PLANNING COMMISSION MEETING STAFF REPORT

NAME OF PROJECT: Haynie Density Reduction Subdivision

Subject: Haynie Subdivision - Preliminary / Final Approval

Horrocks Engineers recently reviewed the Haynie Subdivision plan for Preliminary/Final approval. The following comments should be addressed prior to City Council approval.

UTILITY PLAN

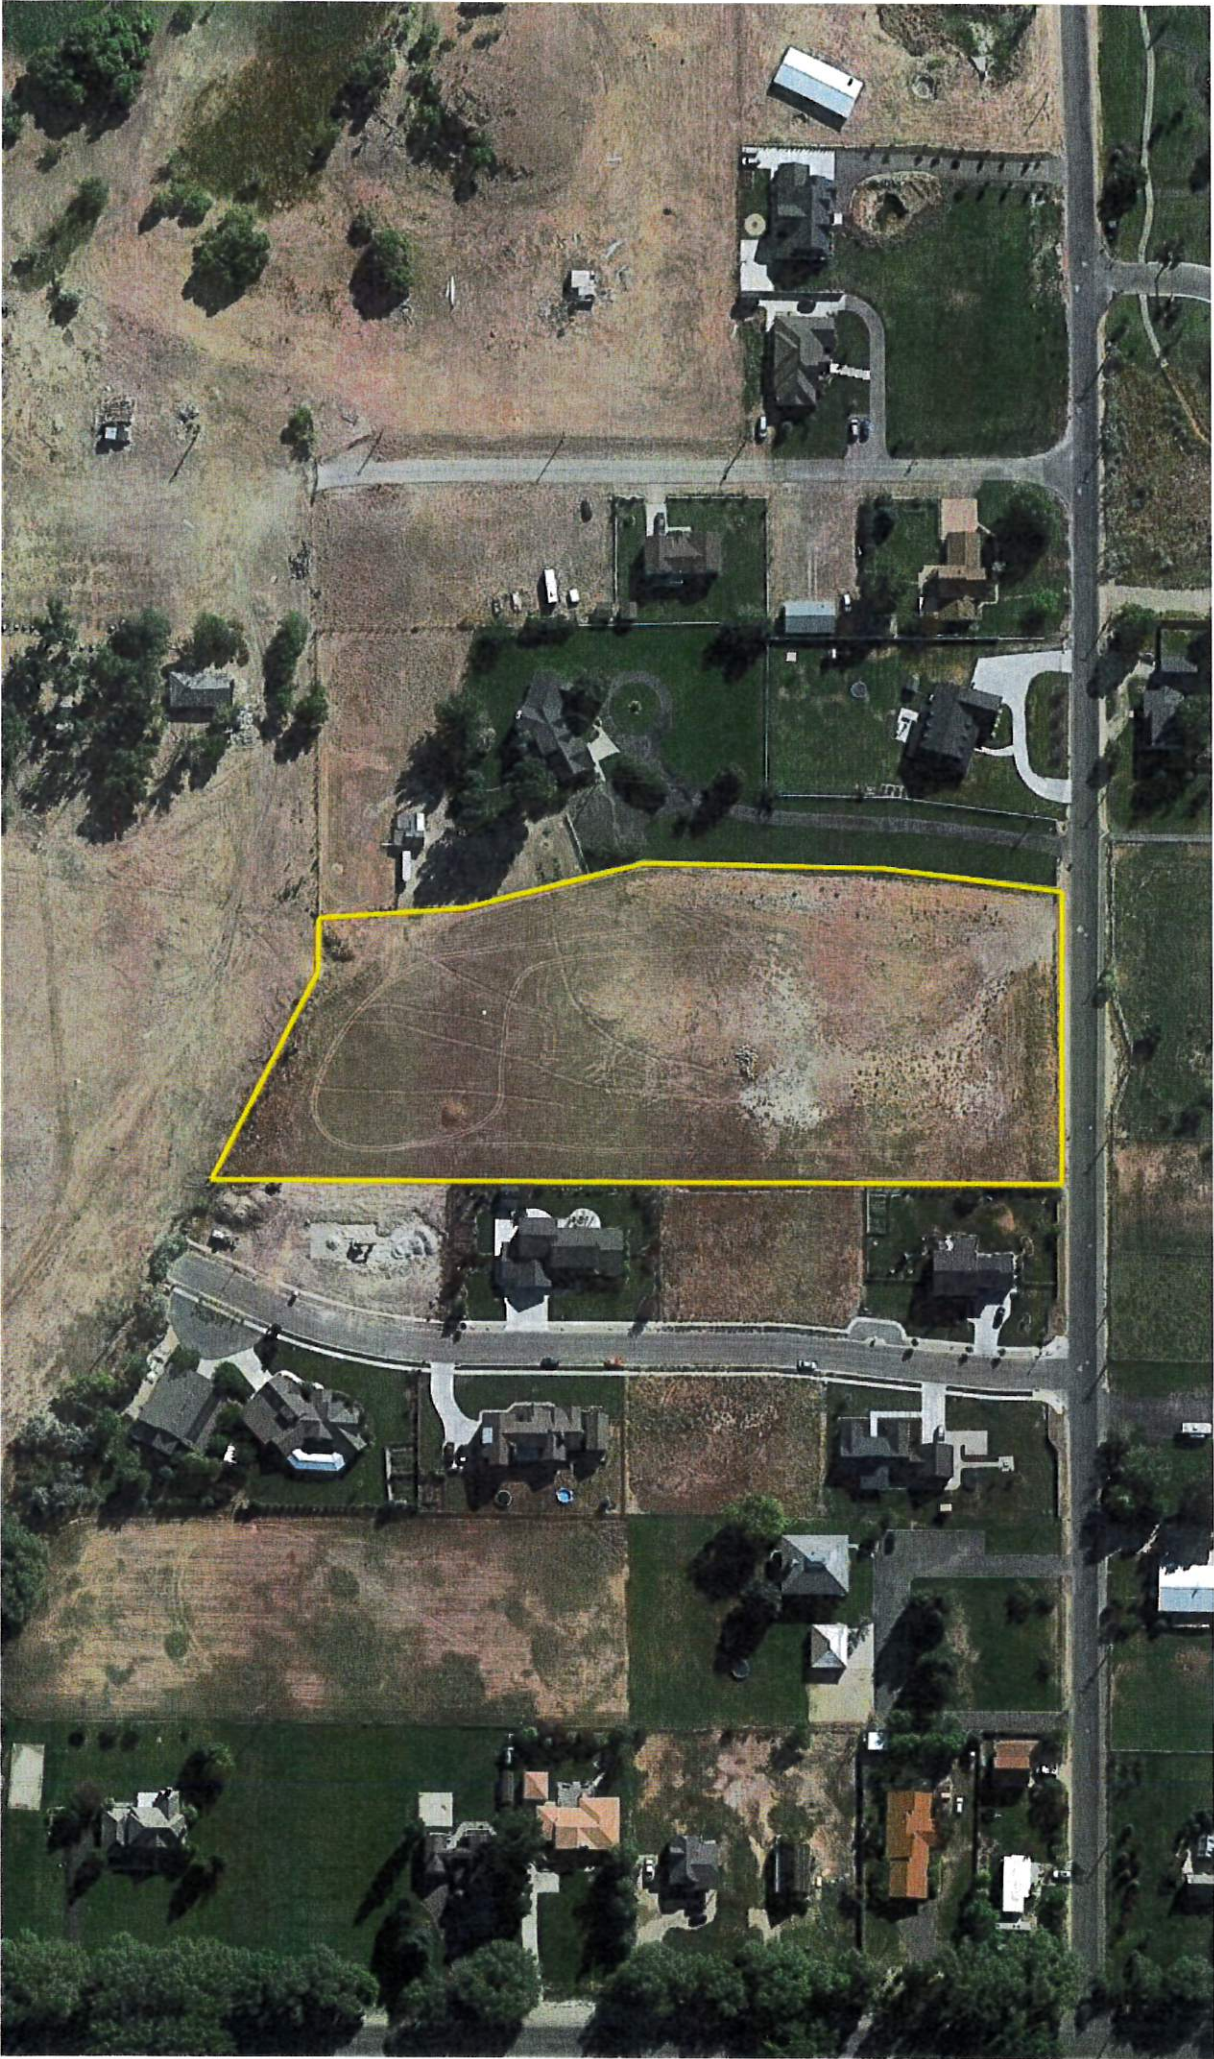
- The proposed development will be served from the Gerber Mahogany pressure zone.
- There is an existing 8" stub to the east end of the proposed development. This should be abandoned and the valve removed.

- The proposed subdivision will need to provide an irrigation service to each lot.
- There is an existing 4" PI stub to the east end of the proposed development. This should be abandoned and the valve removed.
- A min of 4" line will need to be installed to lot three to provide adequate service.
